Exhibit 4: Proposed Route
Prestonsburg - Thelma
Transmission Line
Rebuild Project

Kentucky Power Company
KPSC Case No. 2025-00346
Commission Staff's First Set of Data Requests
Dated January 14, 2026
Page 1 of 2

Aerial Map 9 of 12
Affected Landowners

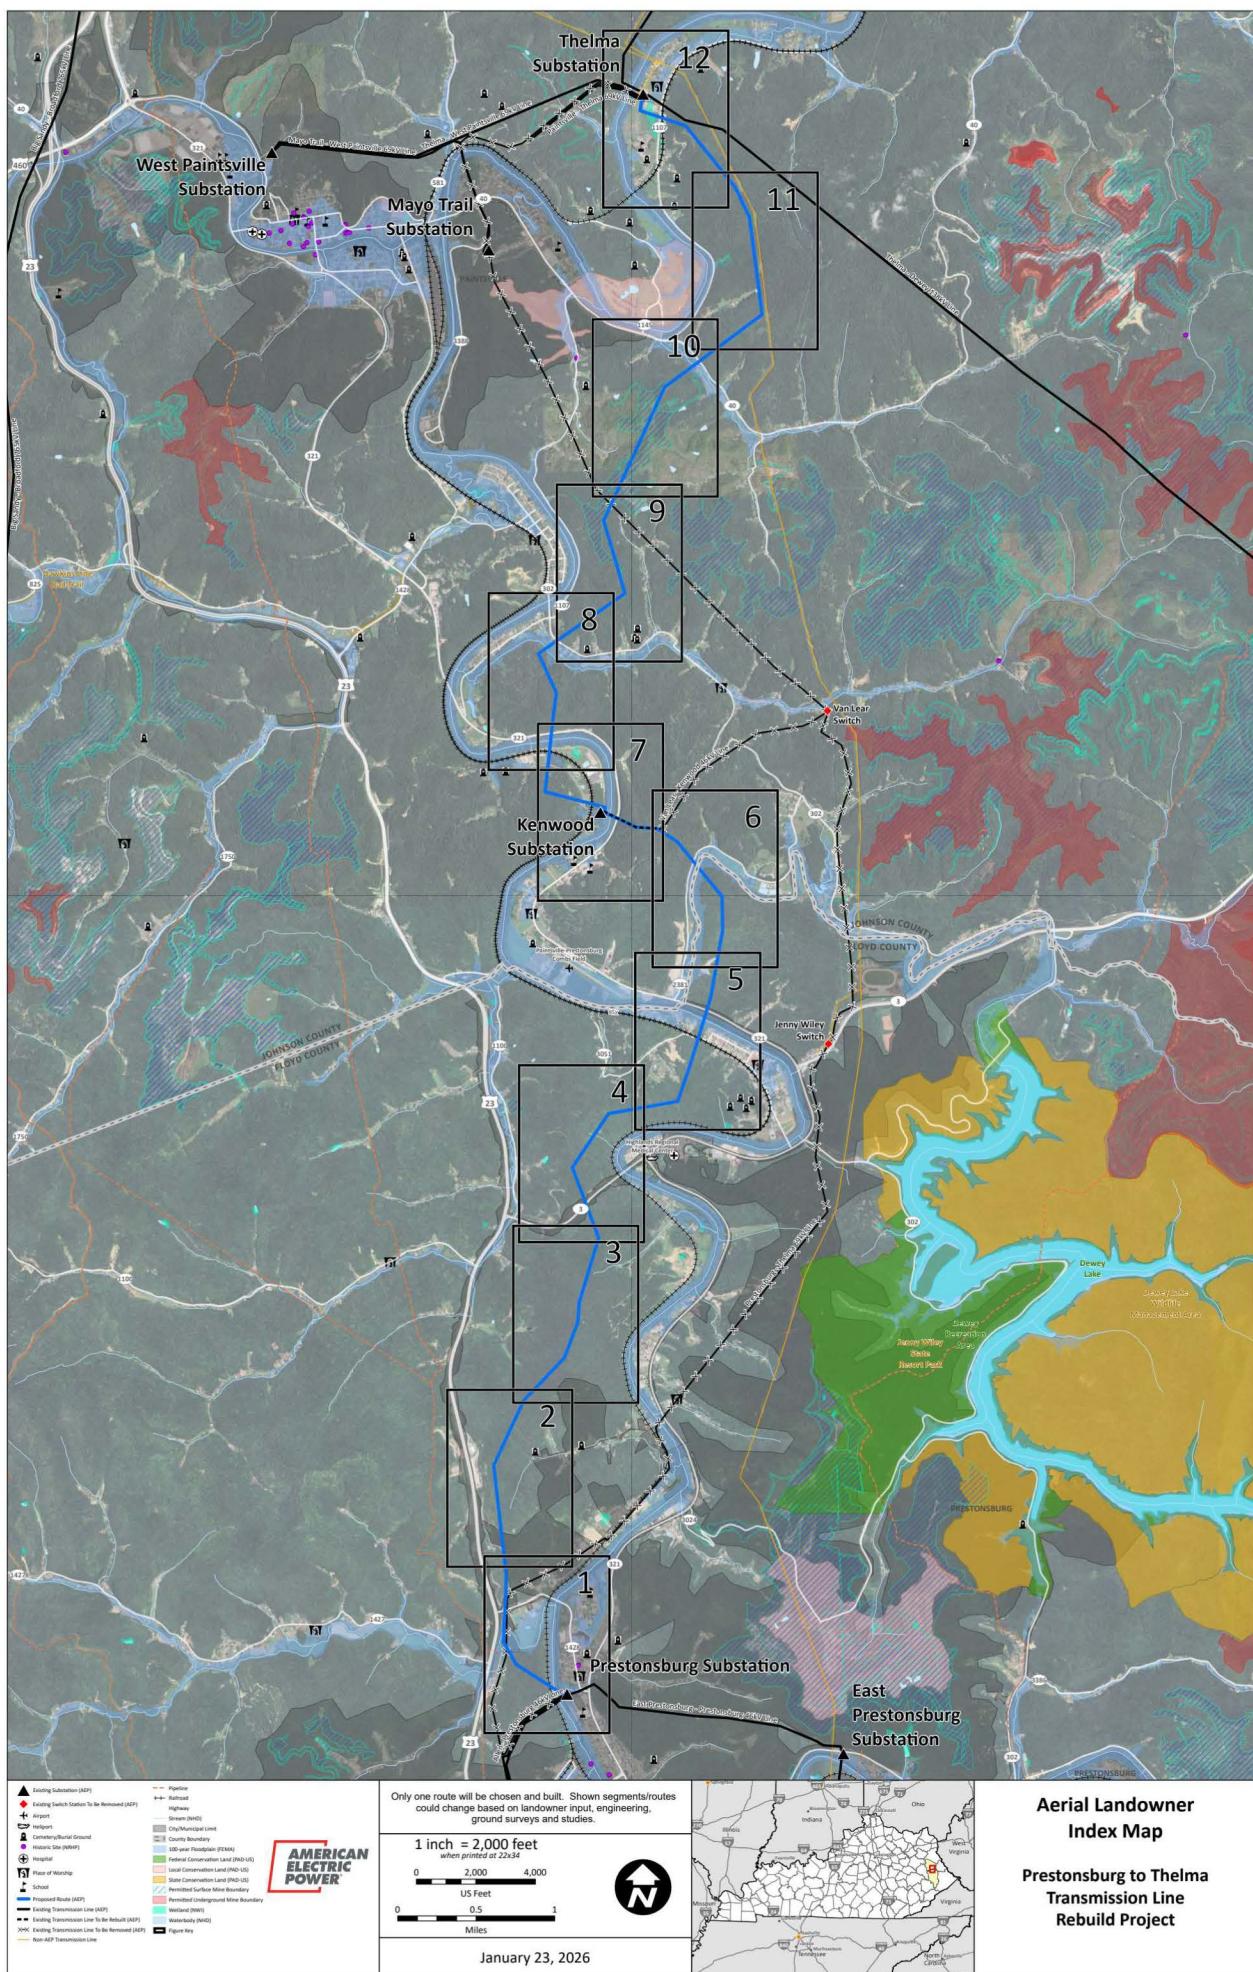
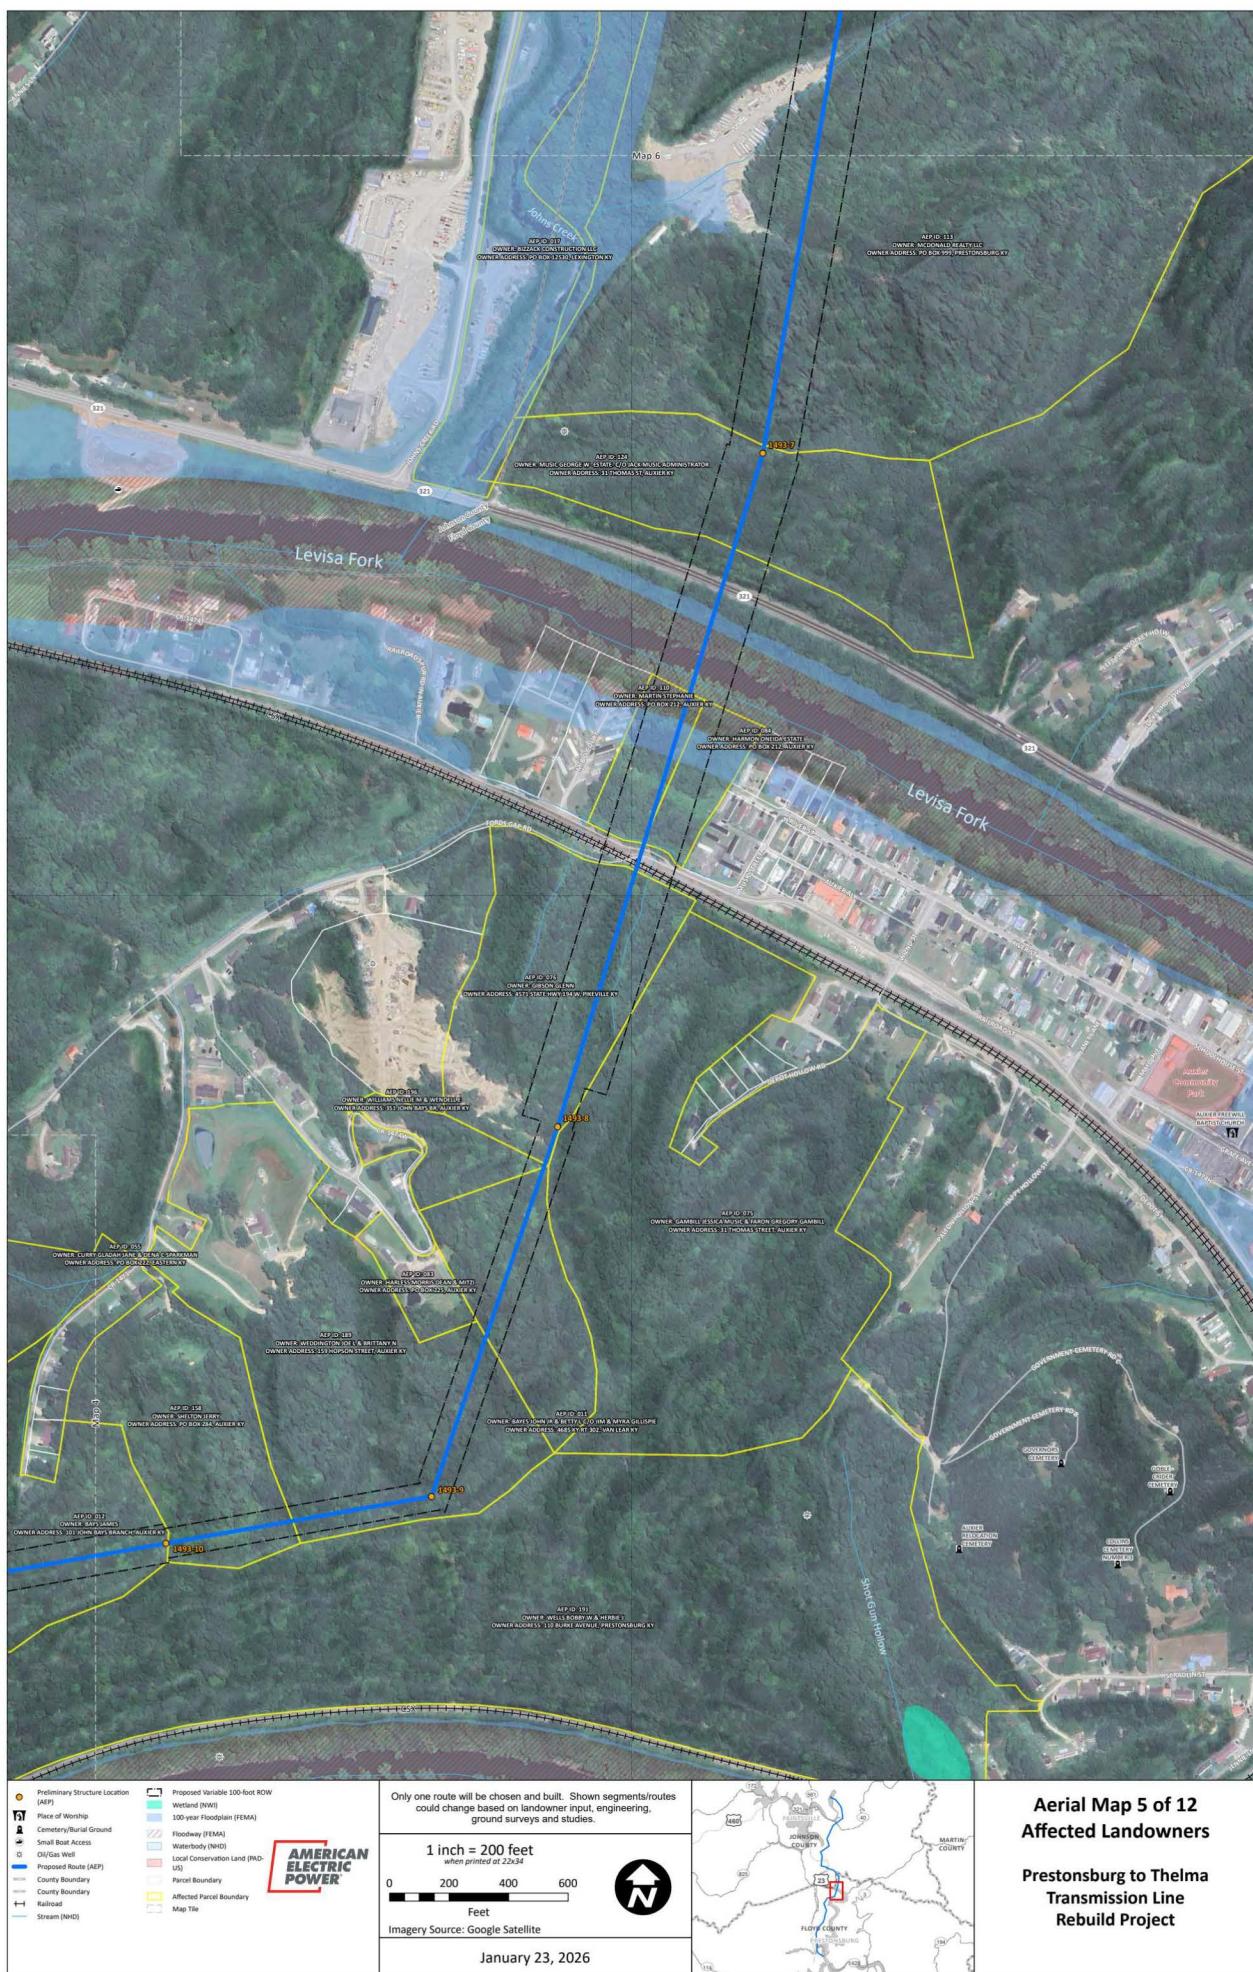
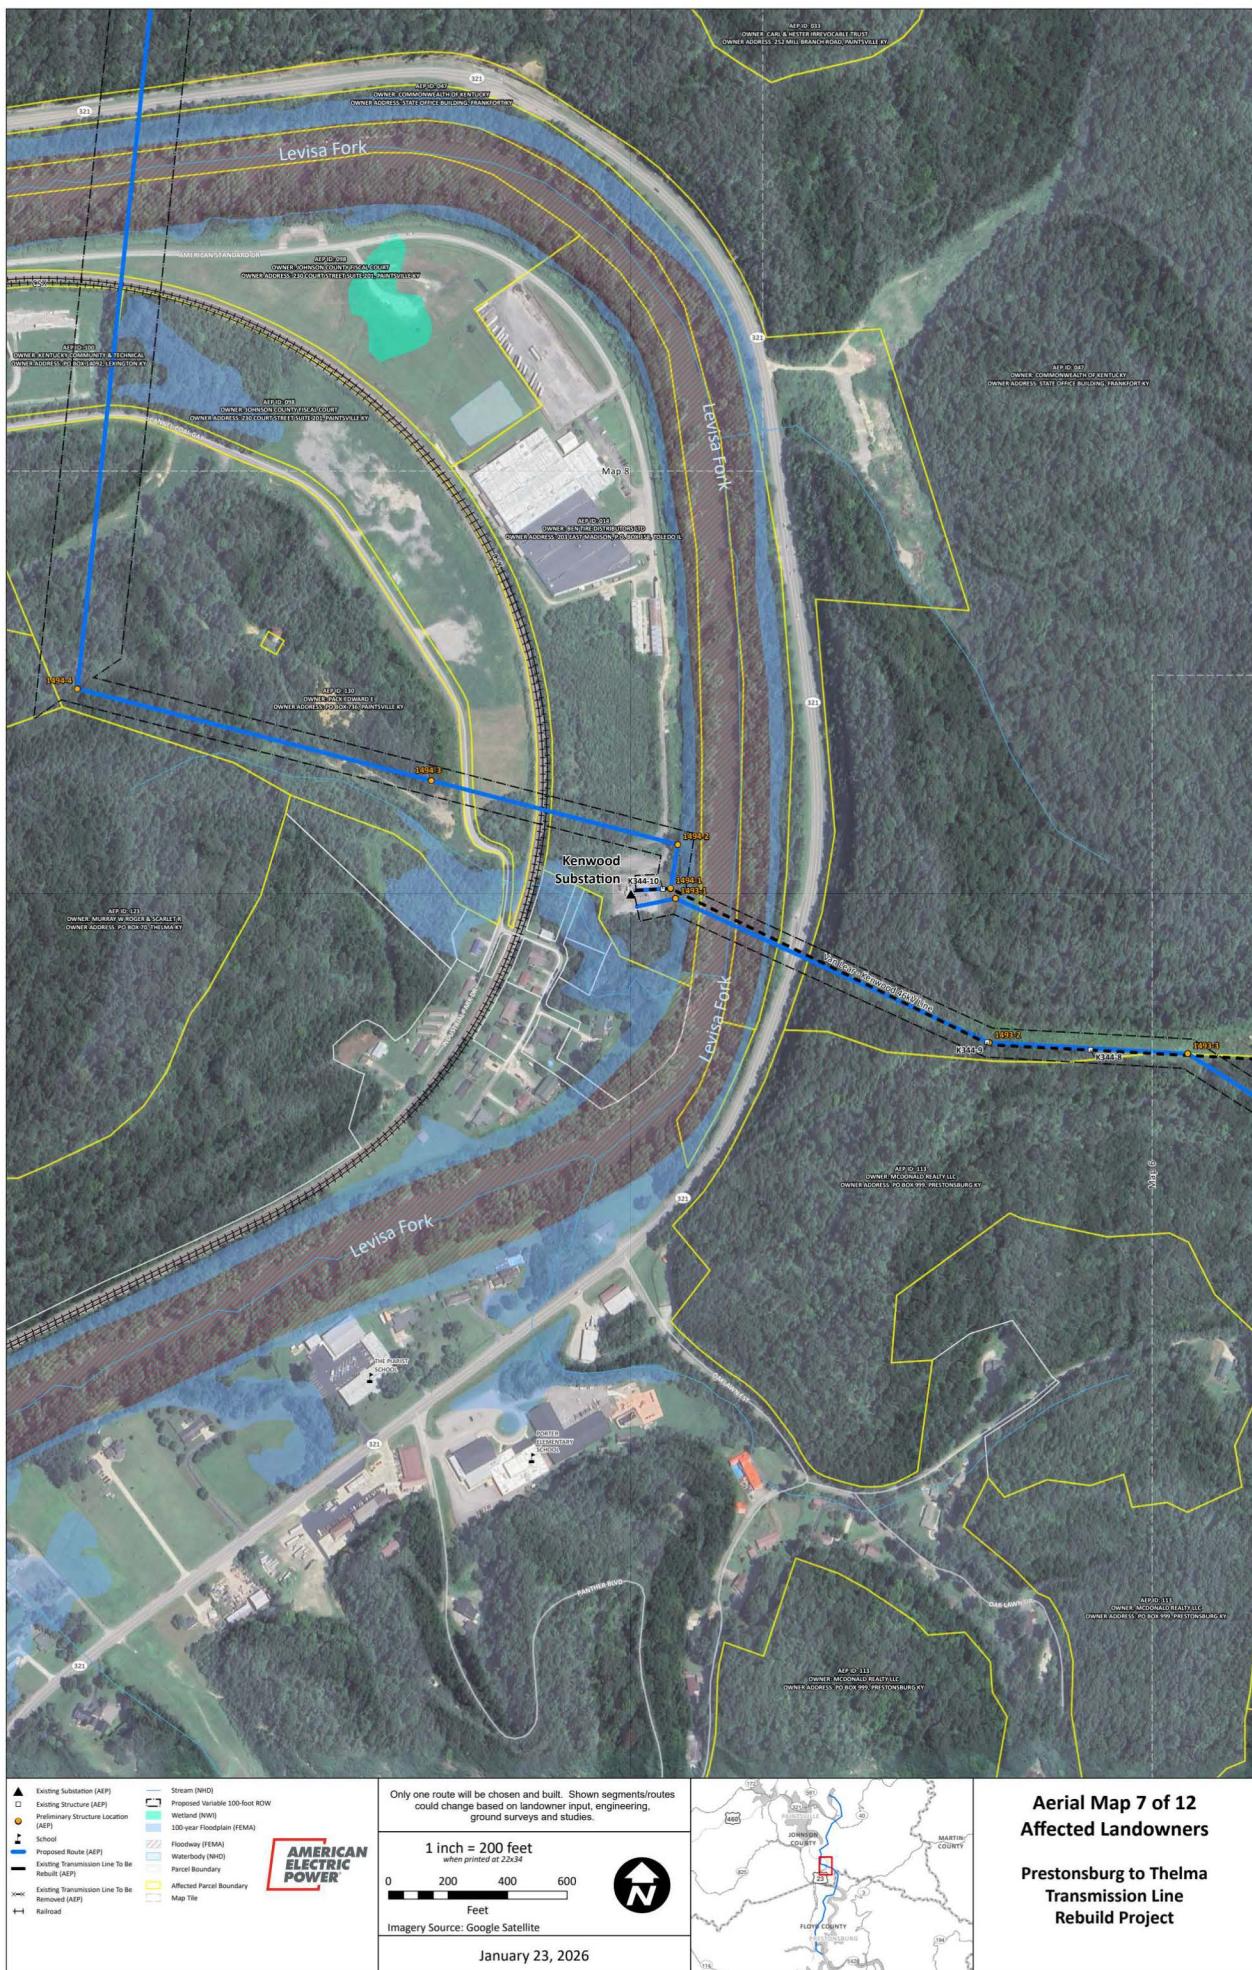
KPSC 1_33 Refer to the Application, pages 13–14.

- a. Provide an updated list of all Affected Landowners identified by the records of the property valuation administrator of Floyd and Johnson Counties, Kentucky.
- b. Provide a map showing the Affected Landowners' individual parcels of land in relation to the proposed Project route. Include data indicating the owner of each individual parcel of the map

- a. The Company used the PVA data and took additional efforts to update that list beyond the data provided. That list was updated in October, 2025, which was included in Exhibit 8 of the Application. The Company is not aware of any updates and believes the list provided to be the most up-to-date.
- b. Please see KPCO_R_KPSC_1_33_Attachment1, which includes a map depicting the landowners' individual parcels of land in relation to the proposed Project route and the owner of each individual parcel.
